Milton Hydro (MH) INTERROGATORY #1 List 1

**Issue 7.1 and Issue 7.2
Issue: Cost Allocation and Rate Design**

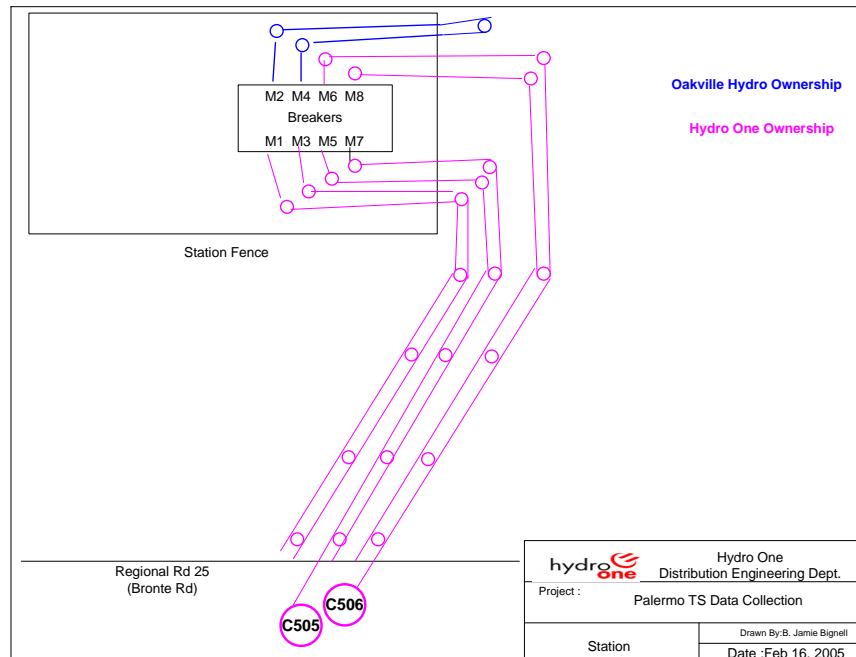
Attached to this document is a map prepared by Milton Hydro, which shows schematically the area surrounding the Hydro One Networks' Palermo Transformer Station ("Palermo TS") in Oakville abutting Halton Regional Road 25, the boundary with Milton, near the point at which Hydro One Networks' Corridor crosses Regional Road 25.

Can you please confirm that the schematic map reasonably portrays the position of the Palermo TS, the location of Hydro One Networks' property, the location of the M-1 and M-3 feeders which supply Milton Hydro, the M-5 and M-6 feeders that supply Burlington Hydro, and the M-8 , M-7, M-4 and M-2 feeders that supply the Town of Oakville.

For greater clarity regarding the relative position of Palermo TS and the feeders that connect at this station, Hydro One also provides the attached diagram.
